RC245009

s92 - Request for Further Information

I have reviewed the resource consent application **RC245009** by Cornerstone Rolleston Trust to establish a place of assembly at 999 Goulds Road, Rolleston. More information is needed so that I can better understand your proposal and its potential effects.

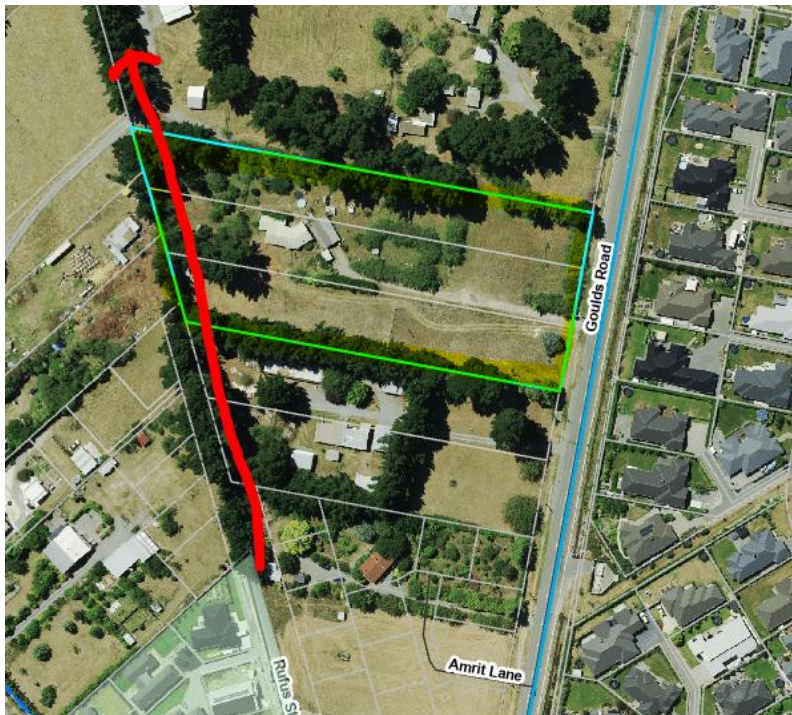
- c) There will also be a need to provide the half road for the extension of Rufus Street as per the ODP for the area, and a walk/cycle connection at least to that in the future, as indicated below.
